NUCLEAR INSTRUMENTATION SYSTEM
RECORDER SELECTOR SWITCHES AND RECORDERS
CKT 3NME01

SEW DWG. NO. 12179-ESK-11H

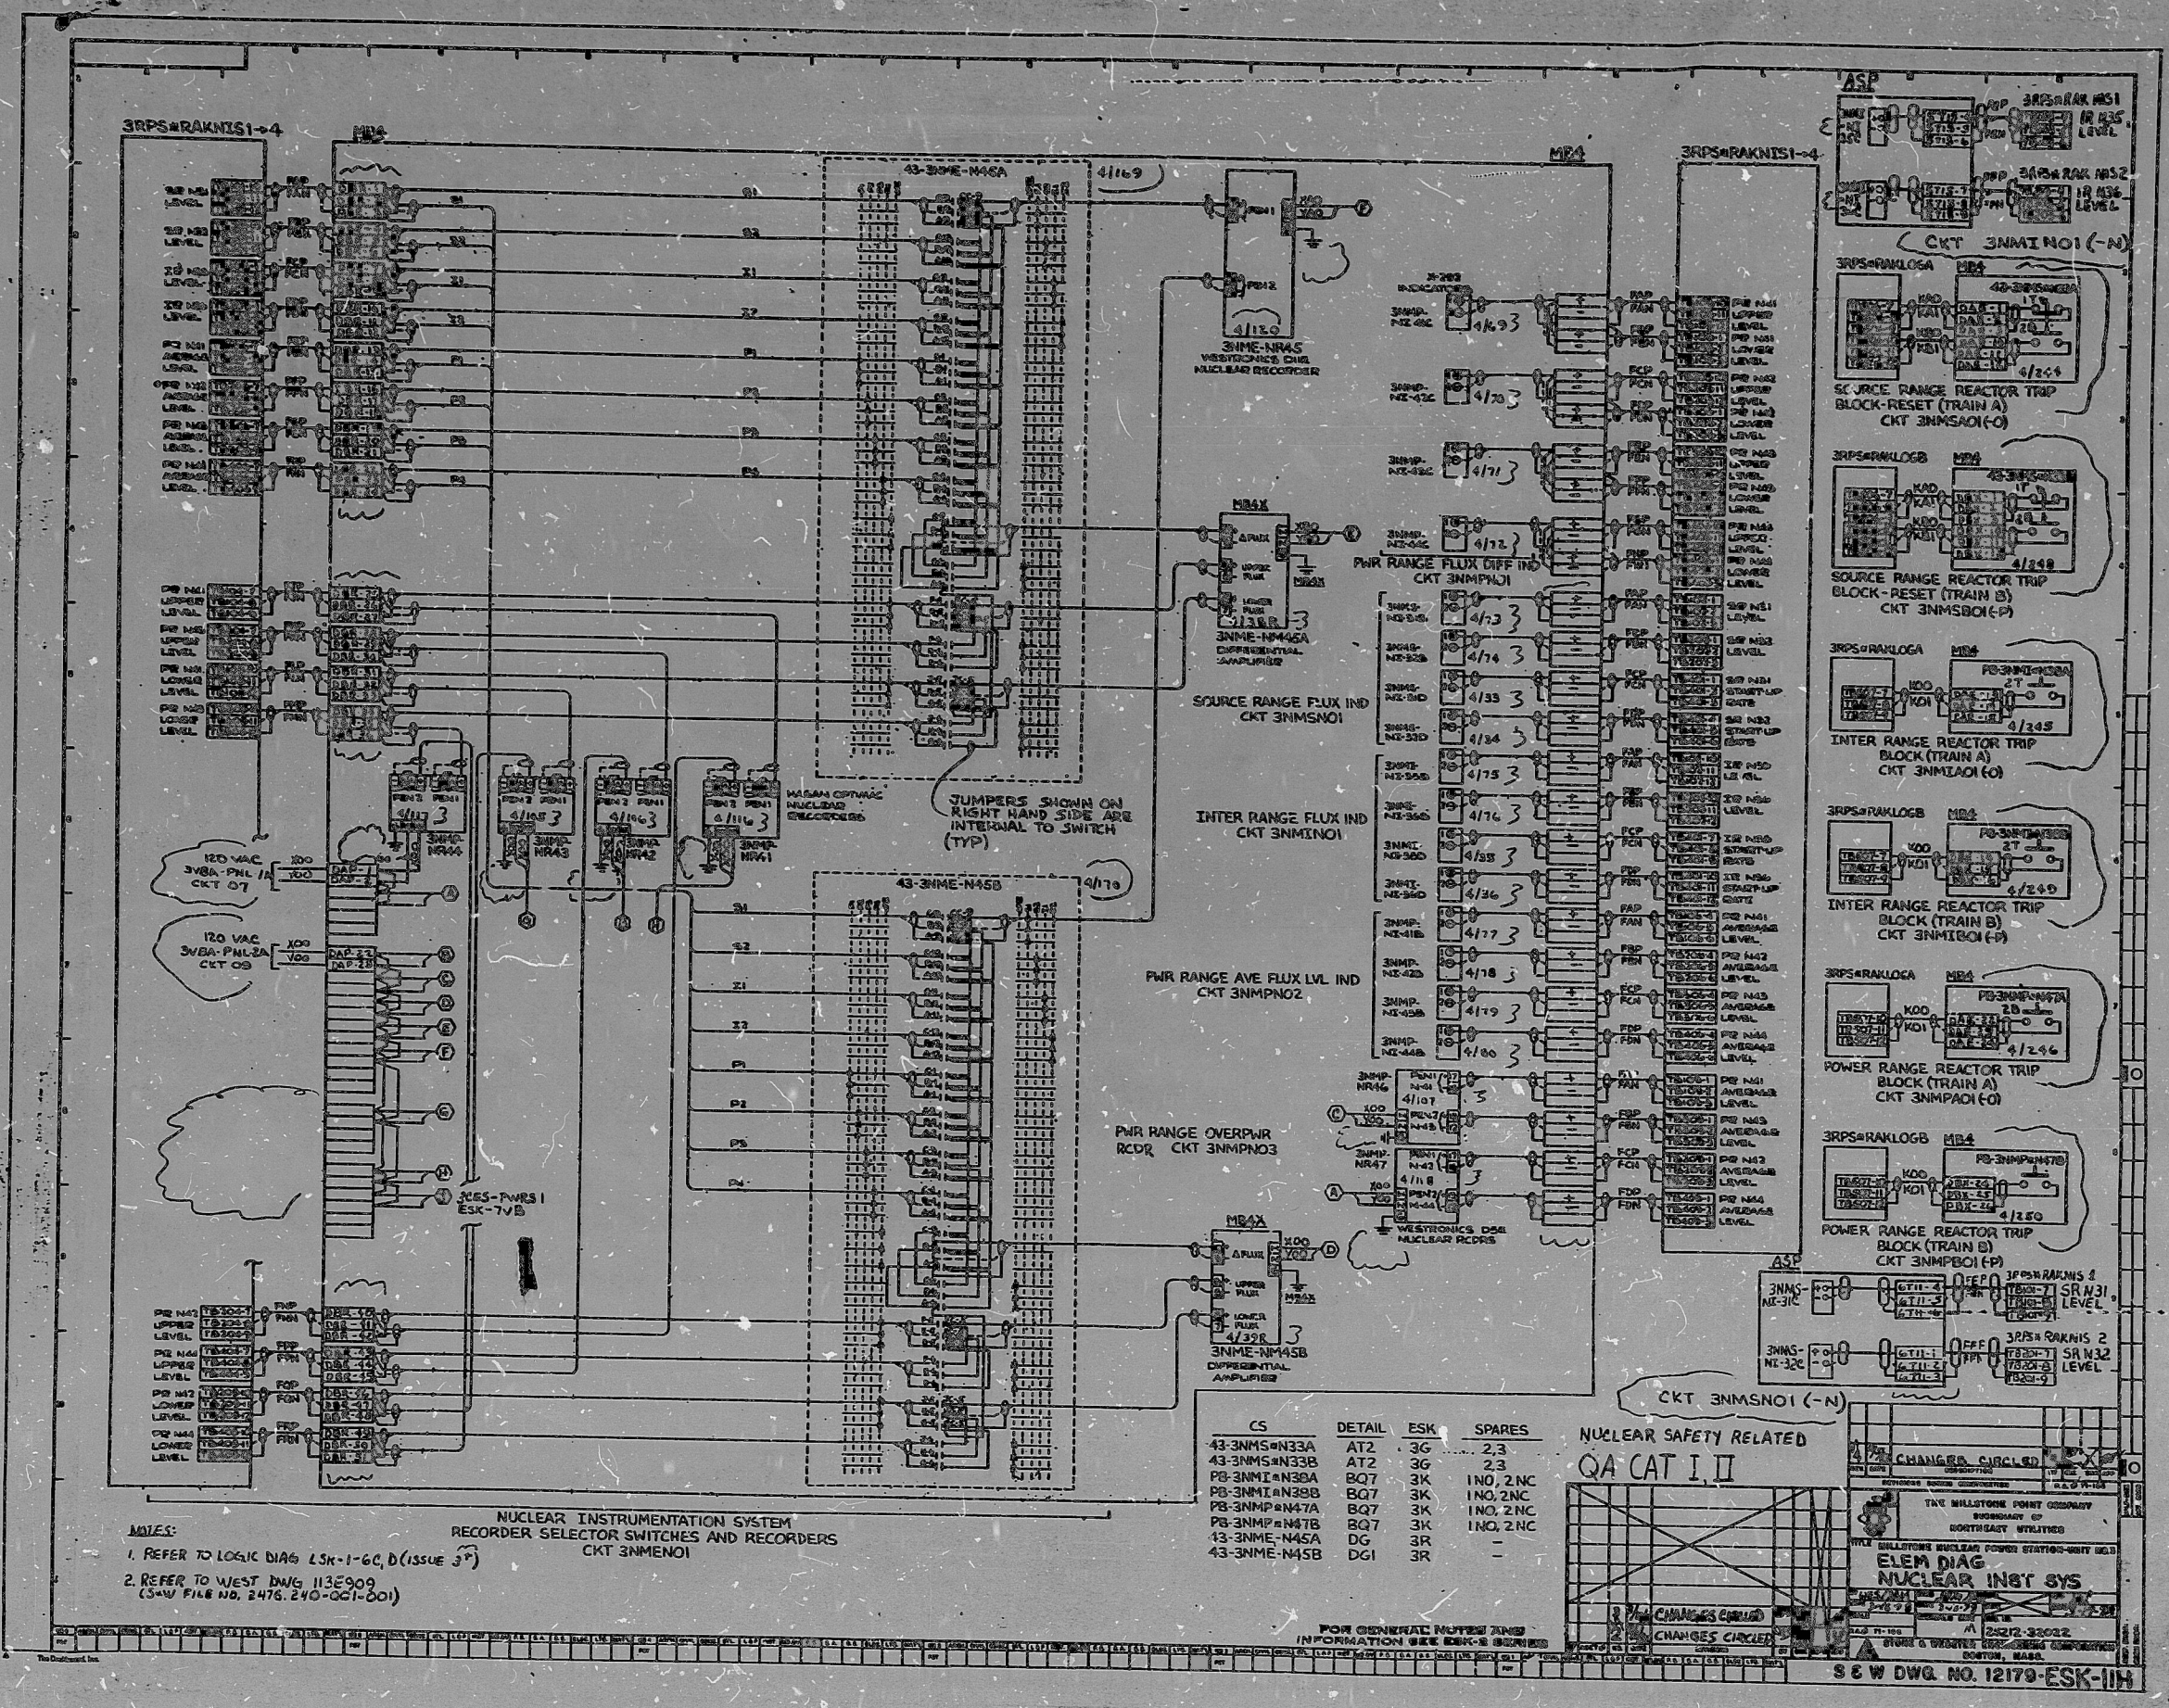
CHANGES CIRCLED

CHANGES CIRCLED
